Groundwater Transfer Review Summary Form

Transfer/PA # T- 14823

Application: T-14823

1. Basic description of the changes proposed in this transfer: POA for Permit G-15416 was drilled in the wrong location which does not match the original authorized location. The purpose of this PA application is to correct this permit by changing the authorized POA location for Permit G-15416 to the proposed POA (KLAM 57409). KLAM 57409 is 1450 ft SW of the originally authorized location.

Figure 1: Application Map

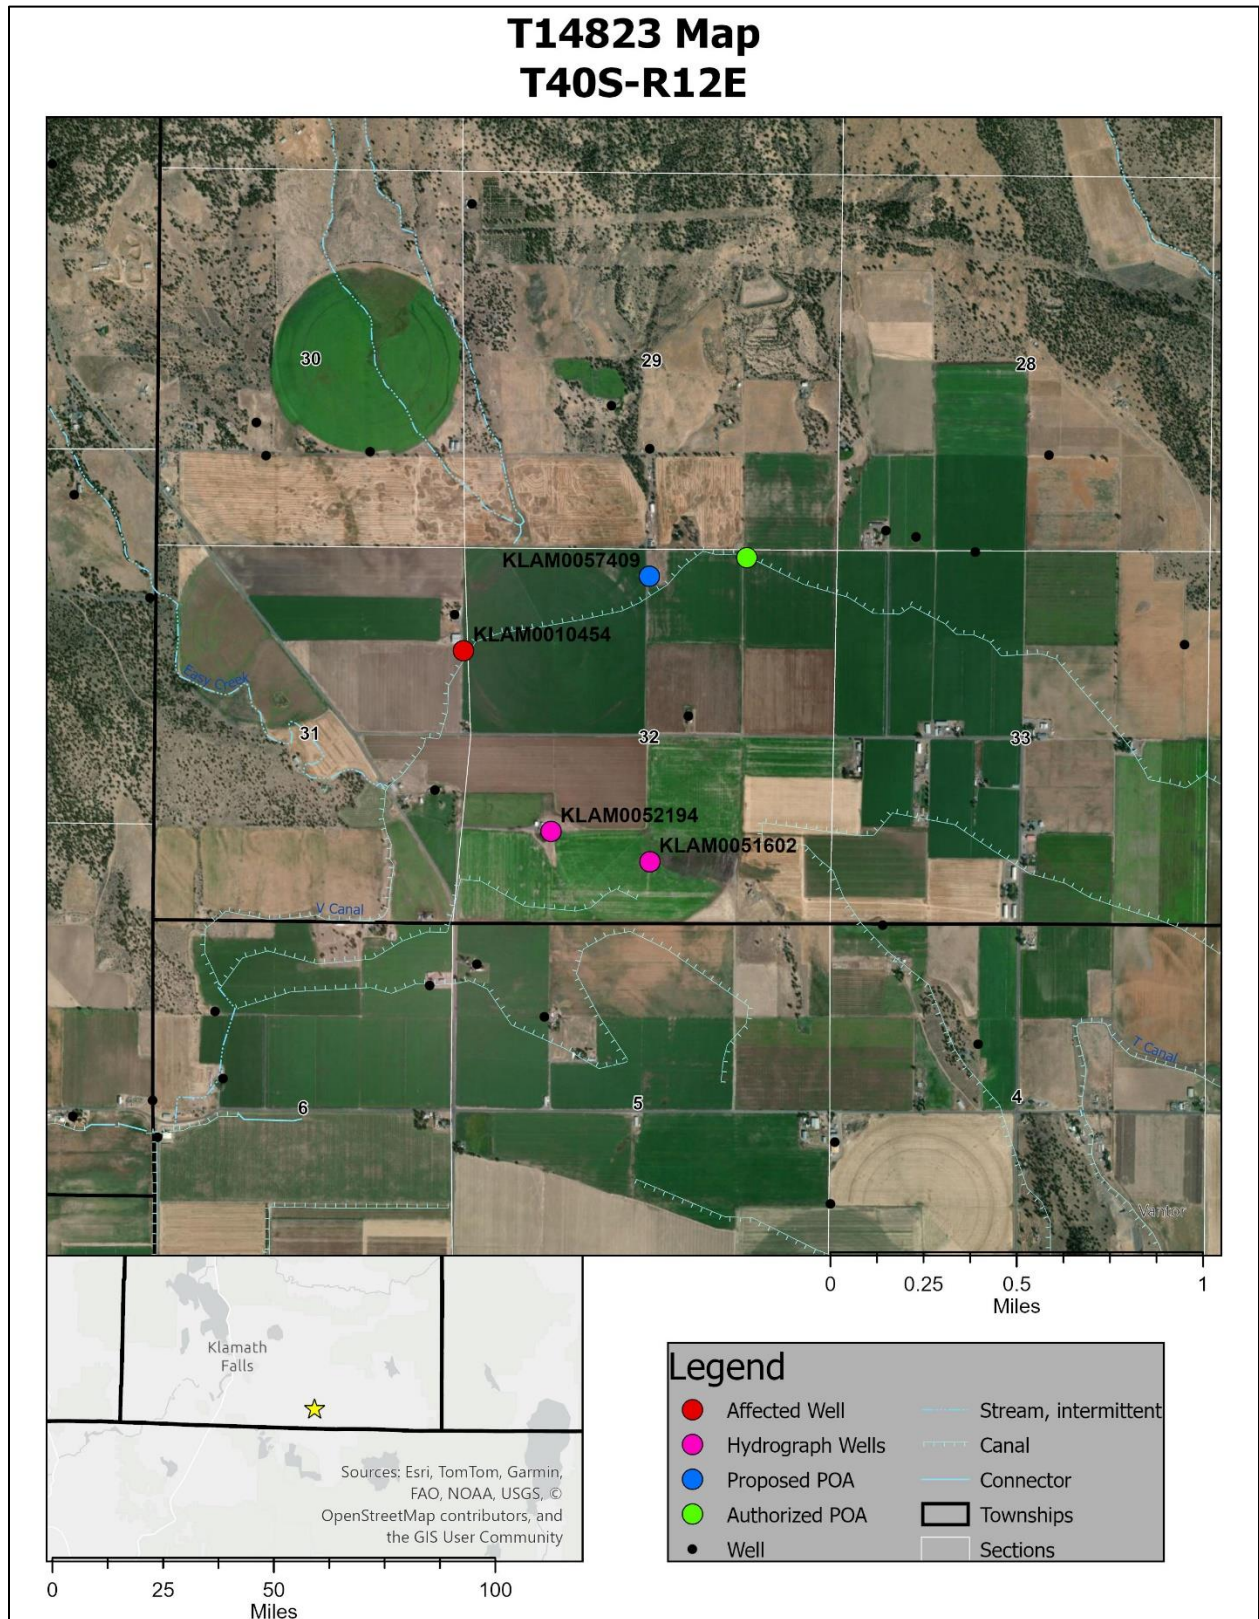
5. a) Will this proposed change, at its maximum allowed rate of use, likely result in an increase in interference with **another ground water right**?
 Yes No Comments: KLAM 10454 is 2800 ft away from proposed POA. The original authorized POA location is approximately 4200 ft away. This reduced distance will result in an increase in interference with KLAM 10454 (Certificate 76381).

6. a) Will this proposed change, at its maximum allowed rate of use, likely result in an increase in interference with **another surface water source**?
 Yes No Comments: Original authorized POA is approximately 33,800 ft away from the Lost River. The proposed POA is 32,650 ft away from the Lost River. The reduced distance to the Lost River will likely result in an increase in surface water interference.

Figure 2: Hydrograph for proposed POA (KLAM 57409)

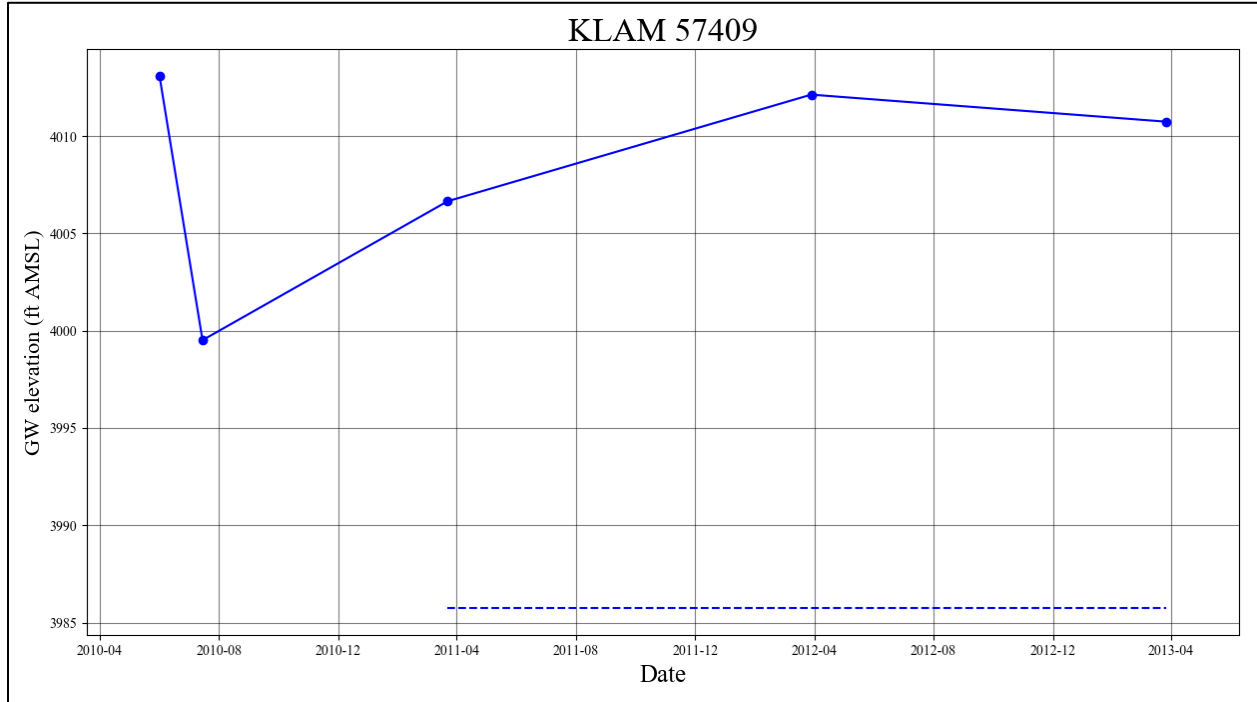
Reference level for KLAM 57409: 164.35 ft BLS (4010.74 ft AMSL) on 3/26/2013. The well has not been measured since the reference level measurement.

A recent attempt to measure this well was made on 4/23/2025 by a pump installer, but they were unable to properly access the well for measurement. Comment by pump installer was, “2 ACCESS TUBES ON E & W SIDE OF DISCHARGE HEAD. READING UNABLE DUE TO CONSTRAINTS BETWEEN CASING AND COLUMN PIPE”.

Since a measurement hasn’t been made since 2013, we must use the best available approximation of water level in this well based on nearby water levels from wells completed in the Tertiary volcanic aquifer north of Malin within T40S-R12E-Section 32.

Figure 3: Composite hydrographs from proposed POA and nearby wells.

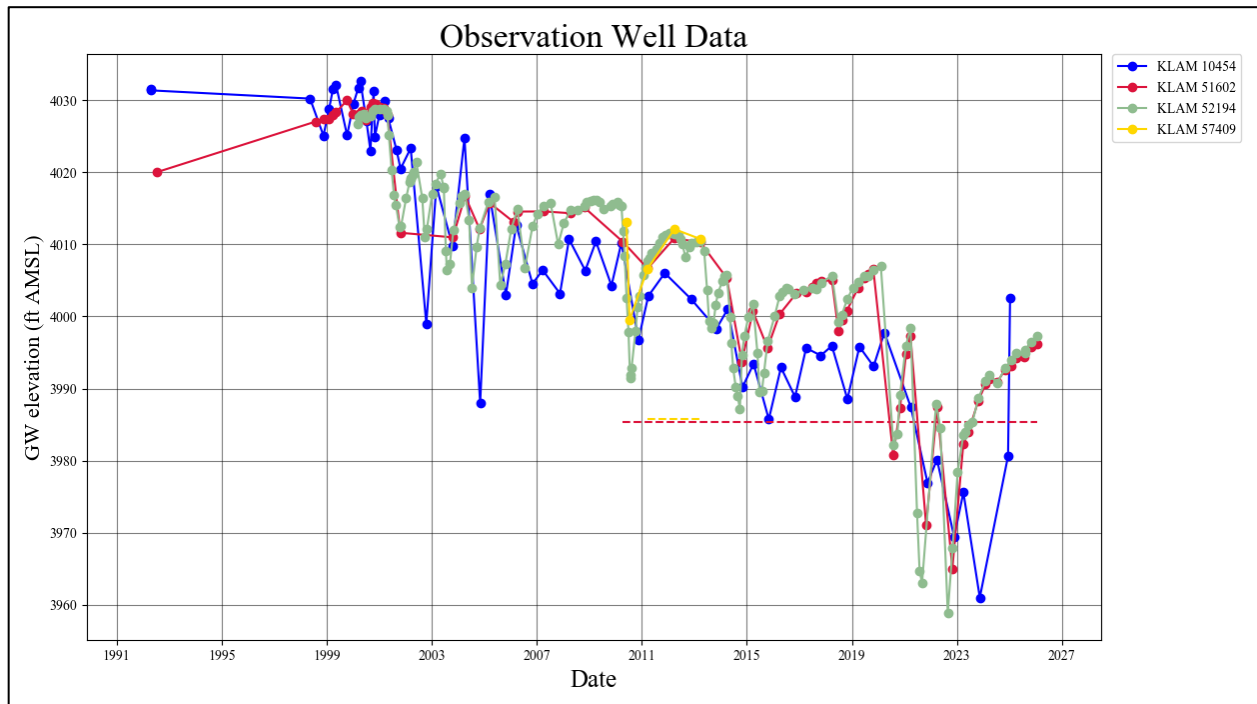
A composite hydrograph of the proposed POA along with KLAM 51602, KLAM 52194, and KLAM 10454 is included as a figure and shows water levels as solid lines and associated permit trigger levels as dashed lines. KLAM 51602 is approximately 4000 ft due south of the proposed POA and KLAM 52194 is approximately 3900 ft SW of the proposed POA. The hydrograph shows that these wells all trend very well with one another and it also shows sharply declining groundwater levels coincident with increases in groundwater pumping from summer 2020 to fall 2022 in the Malin area followed by groundwater levels recovering to 2021 levels from fall 2022 to present.

KLAM 51602 had a reference level set with a date of 4/12/2010 for a since expired Permit G-16737. The 25 ft decline trigger for this reference level is 3985.36 ft and that trigger was exceeded in 07/2020, 10/2021, and 10/2022. Given the similarity in trends for these wells, it is likely that the proposed POA would have exceeded the decline condition as well. While groundwater levels have recovered to levels above the 25 ft decline threshold, there is some concern that increased pumping this season will cause groundwater levels to decline further and once again exceed their decline conditions.

Based on the information presented above, preliminary evidence shows that this well has likely exceeded its decline conditions in the past or has come very close to exceeding decline conditions when groundwater pumping increases in the area. At a minimum, reporting requirements listed in Permit G-15416 should be resumed, specifically, water use should be reported, annual March measurements should resume, and the wellhead construction should be configured in such a way that makes water level measurements possible.
